Fremont K-8 School

2nd Submittal S. Supplement

CITY OF LAS VEGAS INTER-OFFICE MEMORANDUM		DATE: June 20, 2019
TO: Land Development Services Department of Building & Safety		FROM: Albert Sung, P.E. Flood Control Project Engineer Department of Public Works
SUBJECT:	Drainage Study for: Fremont K-8 School	
Cross Streets:	SWQ of Maryland Pkwy. & St. Louis Avenue	COPIES TO: Lochsa Engineering
File Number:	F:\Depot\DSMemos\DS5124B.doc	Clark County School District
Parcel Number:	162-03-801-005	Bart Anderson, P.E., DevCo
Zoning Action:	SDR-76201 & VAR-76200	
FEMA Flood Zone	YES	NO X
Proposed Storm Drain	YES	NO X

**Addendum to
Technical Drainage Study
For
Fremont K-8 School
(MPID#1623)**

5/16/2019 4:13 PM
T:\CAP\181203\Drawings\Drawings\DR2.dwg

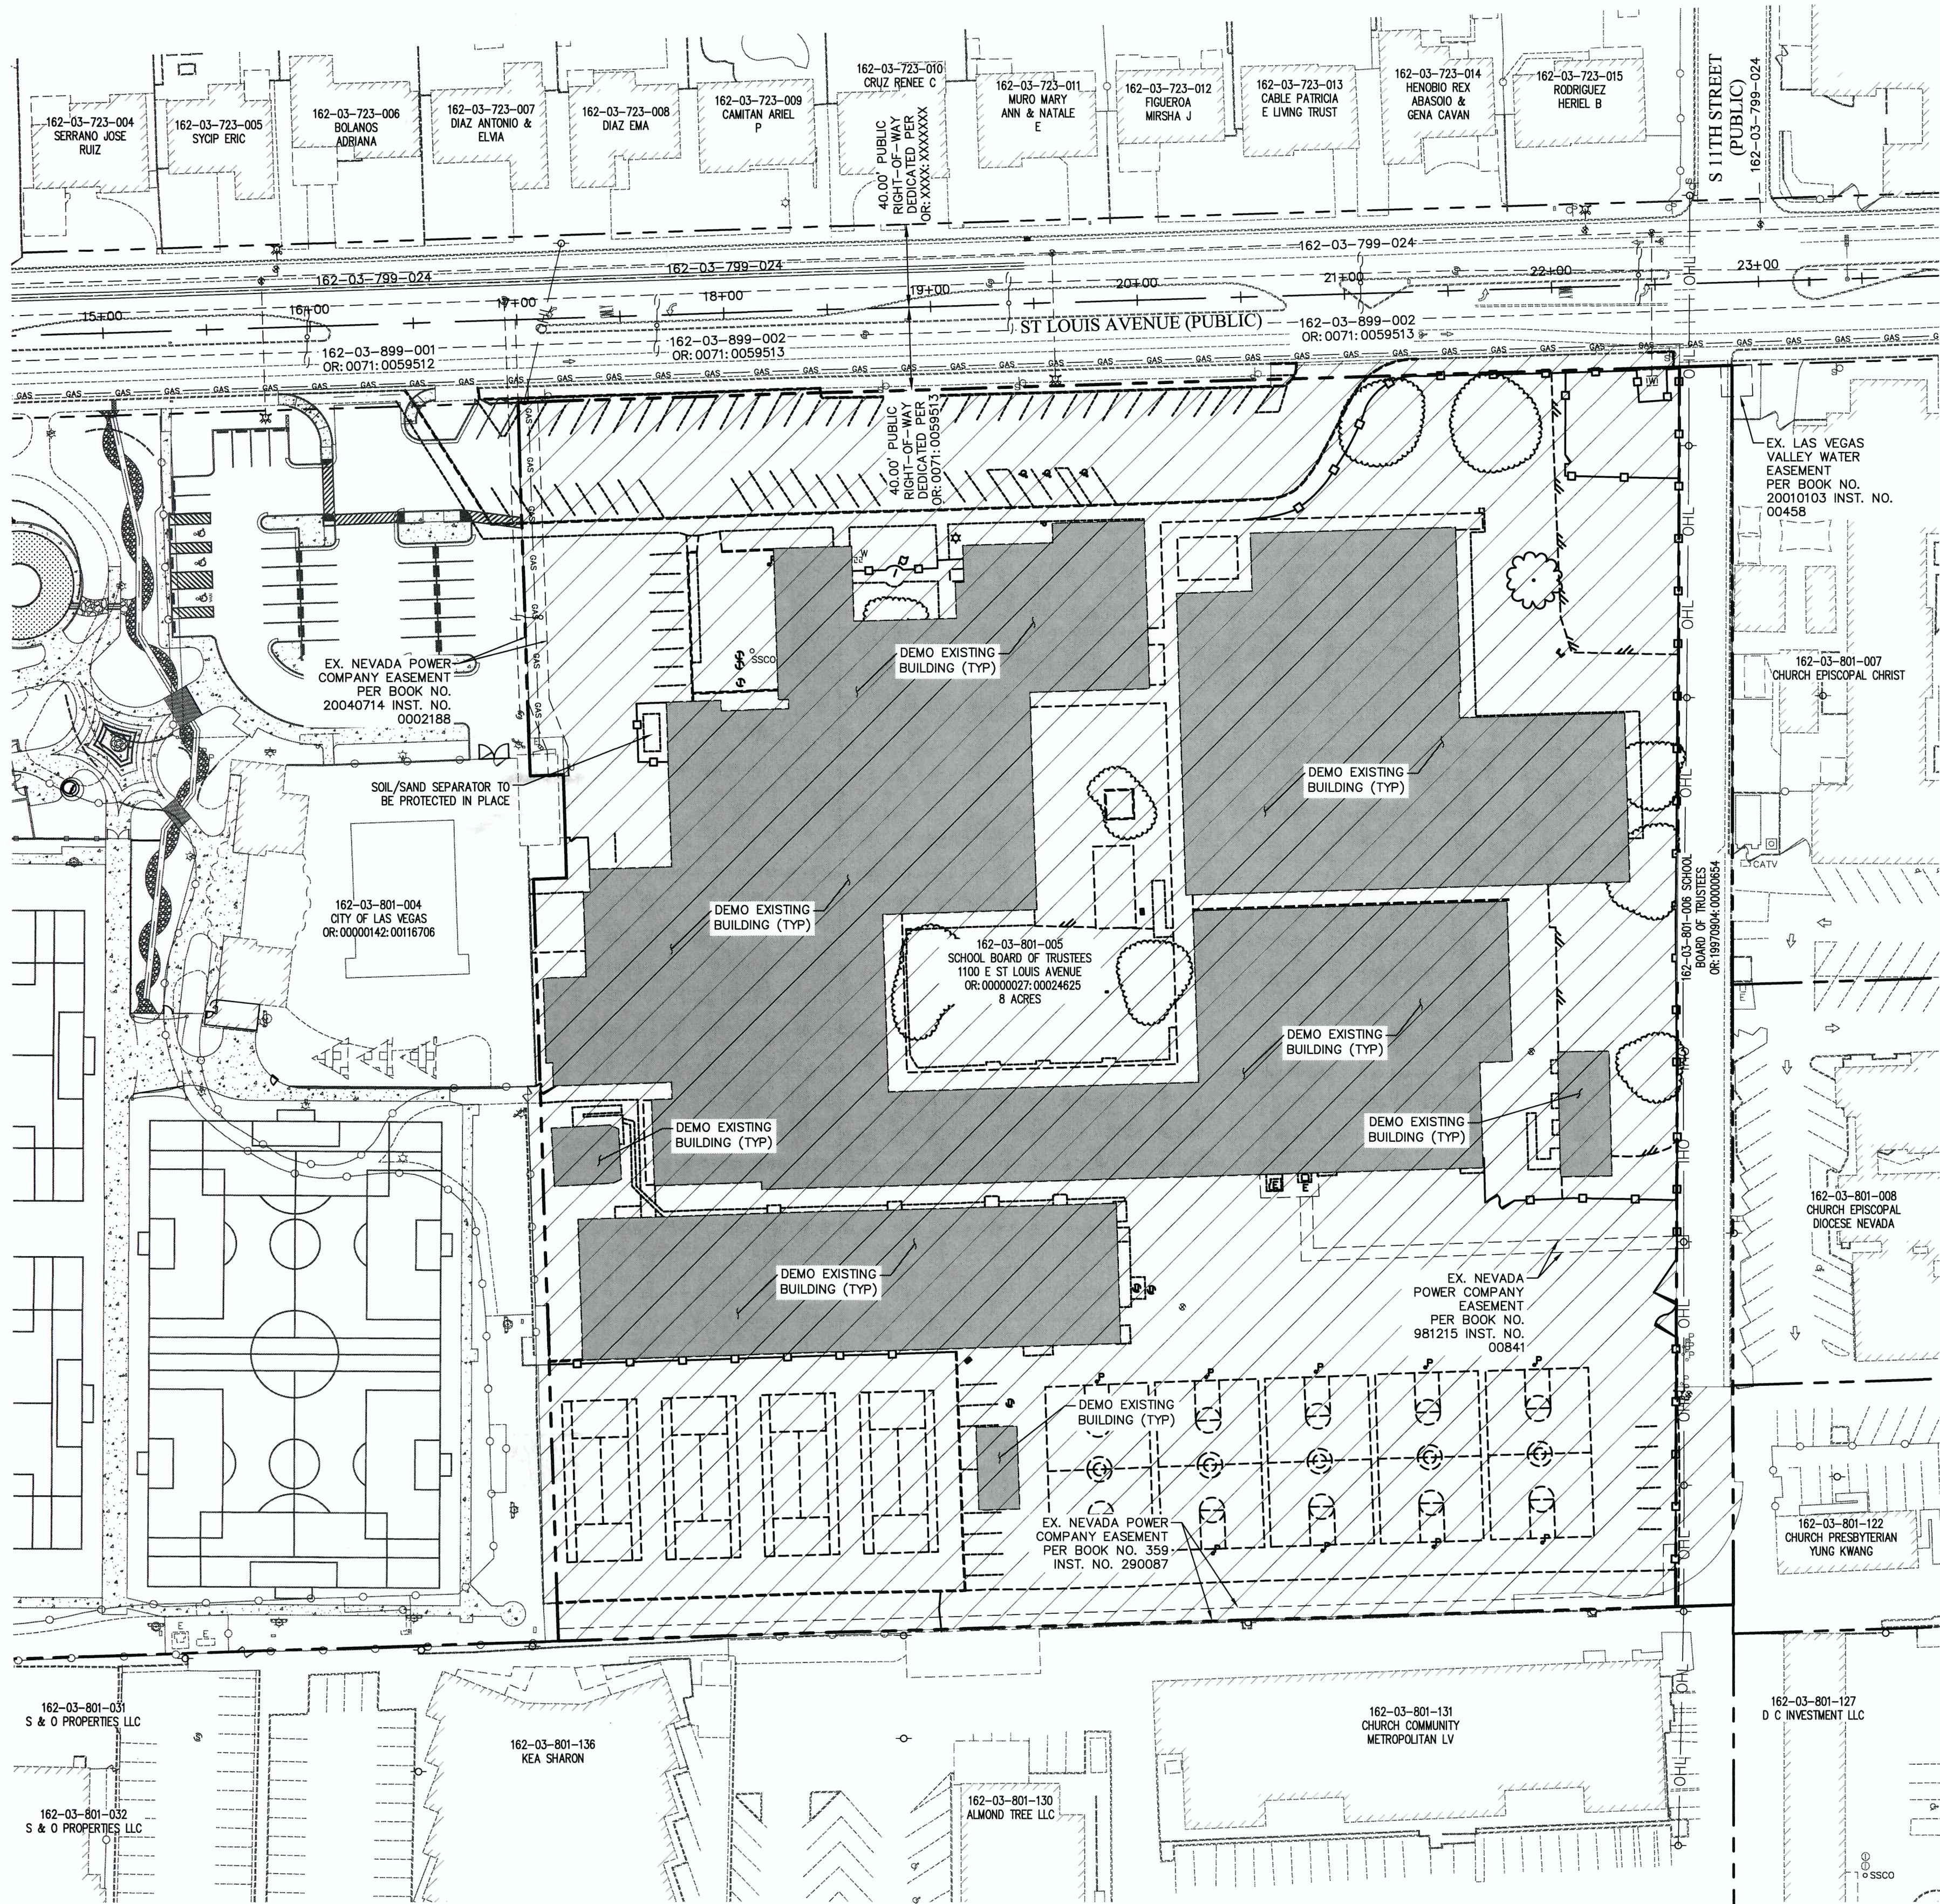
5. *Sheet DR2 (Interim / Developed Basin Map):* It also appears that the location of concentration point CPD1 is not correct. Review and revise accordingly.

Response 5: Noted. The combination point 'CPD1' has been relocated to the northeast corner of basin 'OND1'. Please refer to the revised figure DR2, Interim/Developed Basin Map.

OVERALL DEMOLITION PLAN
PROJECT: ---
DRAWING TITLE: OVERALL DEMOLITION PLAN
FACILITY: FREMONT K-8 SCHOOL MPID #1623

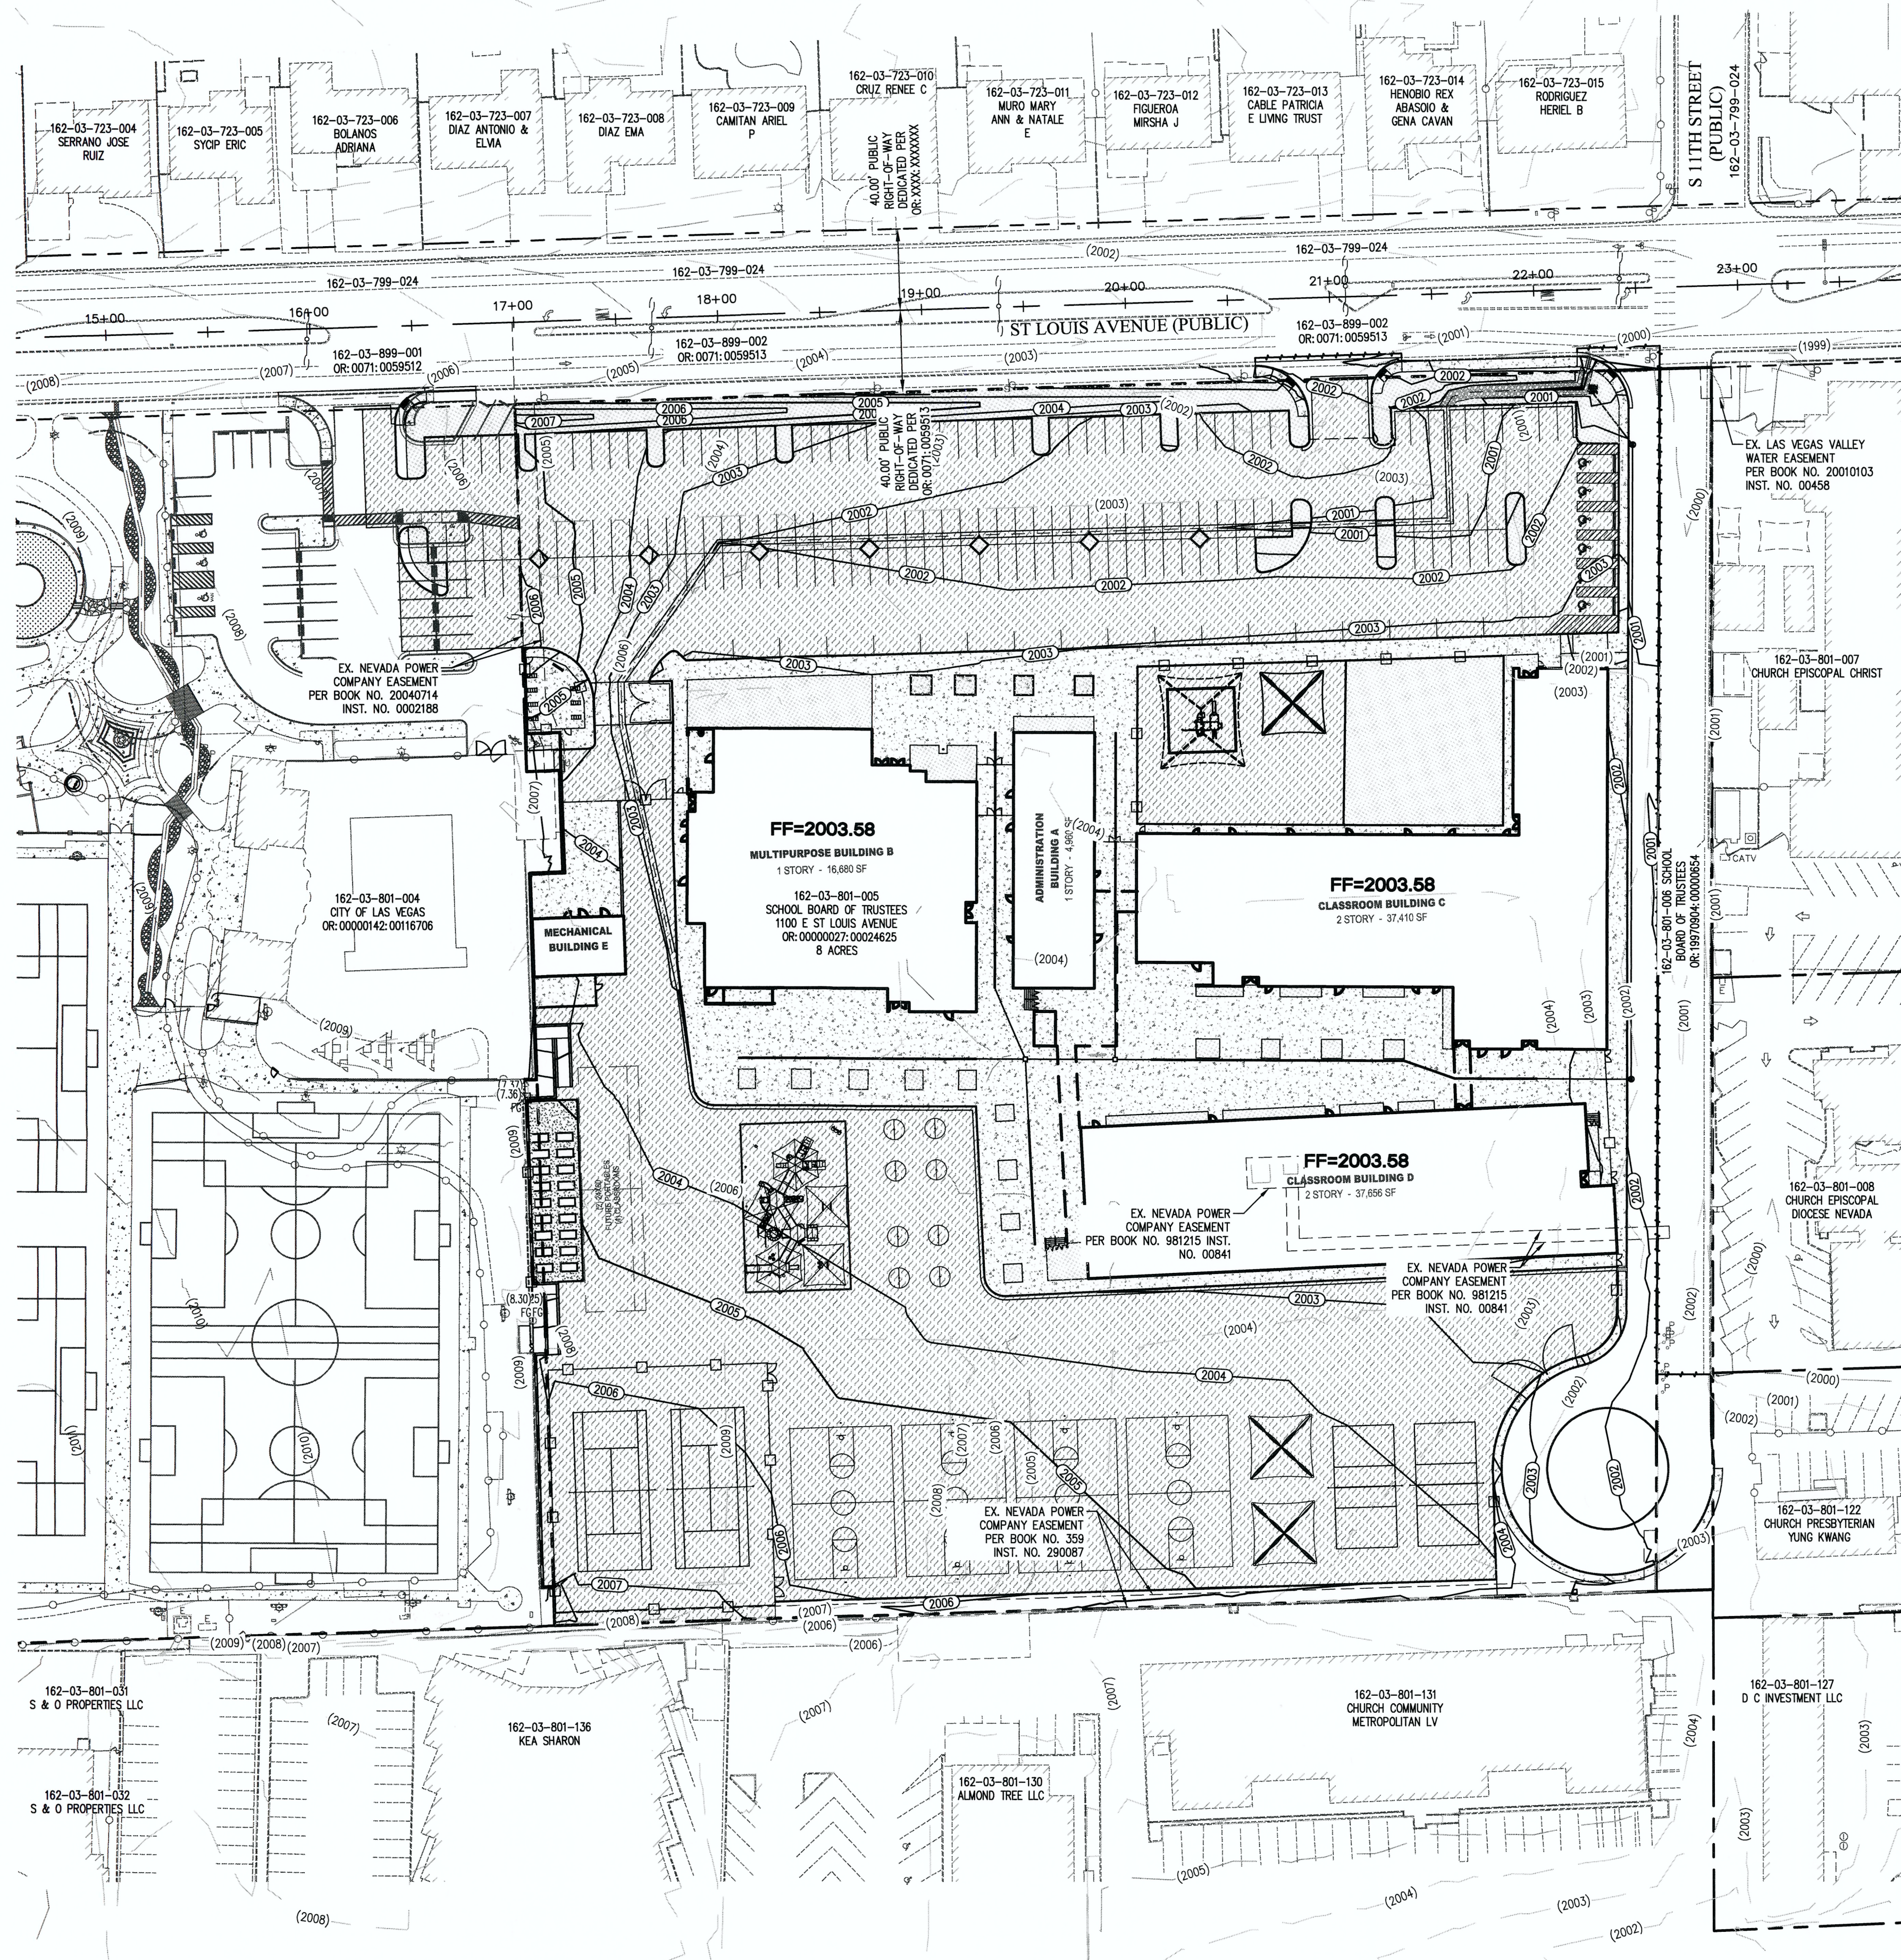
7. Provide a Demolition Plan in the next submittal.

Response 7: Acknowledged. Please refer to the demolition Plan within this addendum along with the grading plan and detail sheet.
